NRL Report No. B-1313
BuEng. Prob. IC-124

Report
of
Test on Fire Alarm Equipment

Submitted by
Chas. J. Henschel and Co., Inc.,
Amesbury, Mass.

NAVAL RESEARCH LABORATORY
ANACOSTIA STATION
WASHINGTON, D.C.

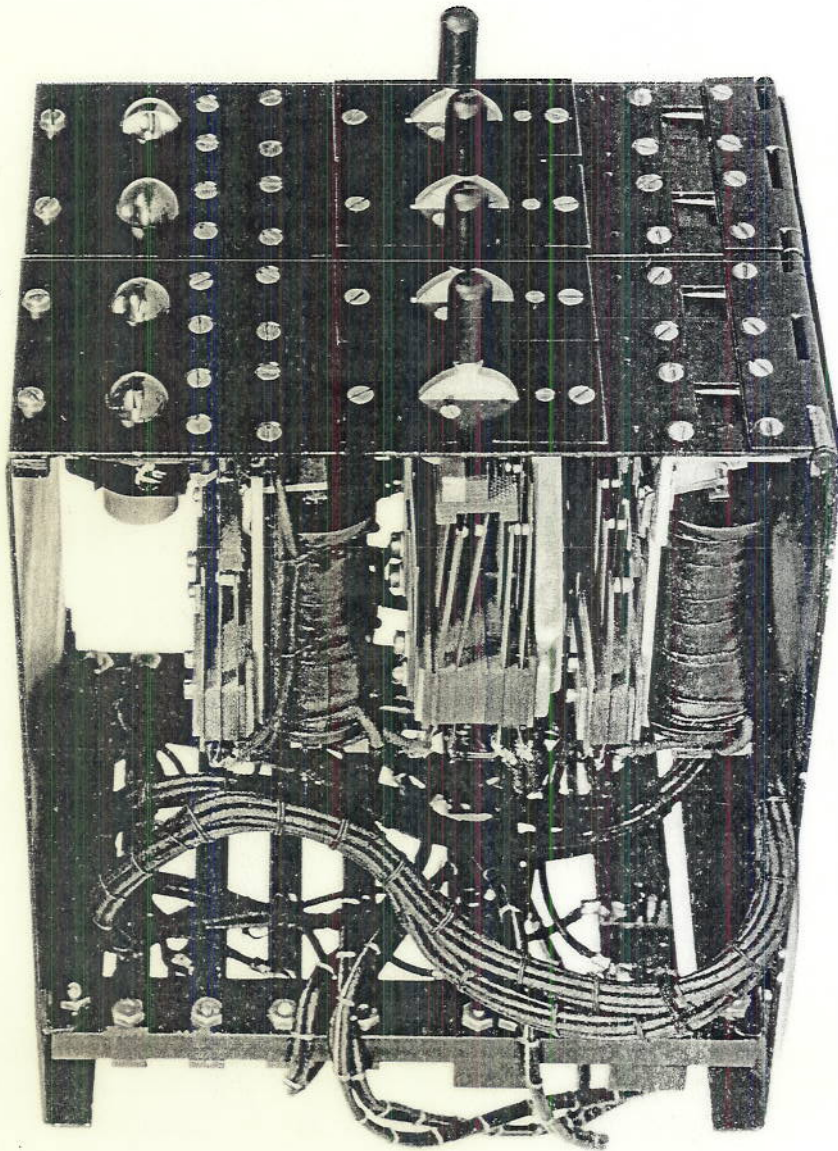
19. The following undesirable features were noted:

- (1) An adhesive tape is used to protect the windings instead of the usual non-hygroscopic material lapped and cemented in the lap.
- (2) The neon lamps are replaceable from the back of the unit only.
- (3) The dust cover is neither separately removable or complete. The two line units should be secured at the top to an independent member supported by brackets. The bus and line terminal assembly should also be supported independently from the dust cover.
- (4) Line terminals, drawing 9-S-1841-L, are not provided on the back of the terminal strip.
- (5) The cloth inserted bakelite insulators on switches and relays should be coated with an approved varnish on all exposed edges.

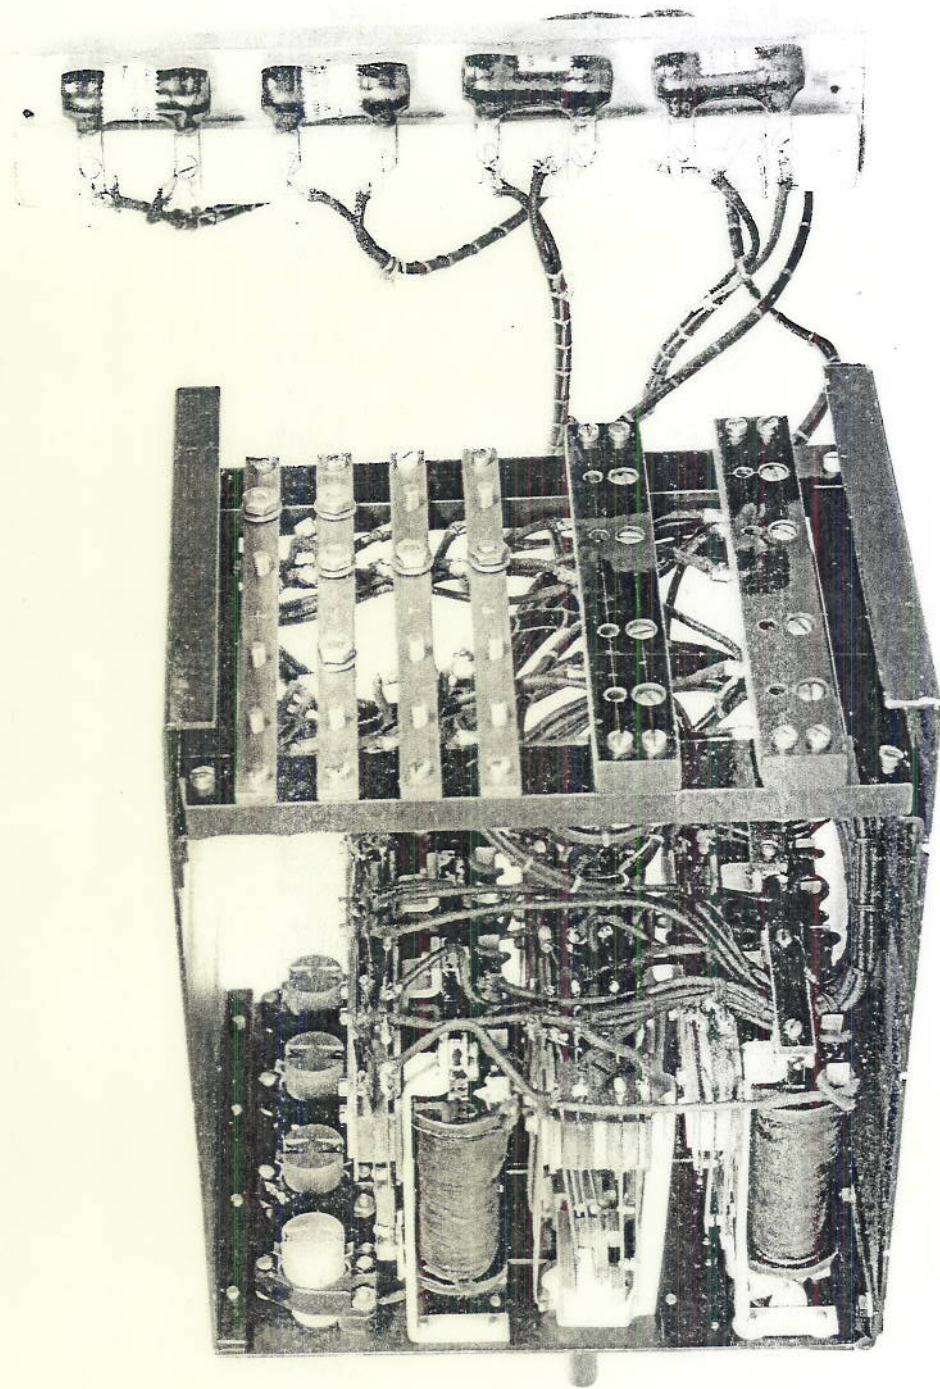
20. As received, the units were not wired in accordance with the latest alteration of drawing, reference (c), and in order to conduct the test the necessary changes were made.

21. As no ground detector was furnished, a temporary one was provided and was found to operate satisfactorily in connection with this equipment.

22. No extension alarm relay was furnished.
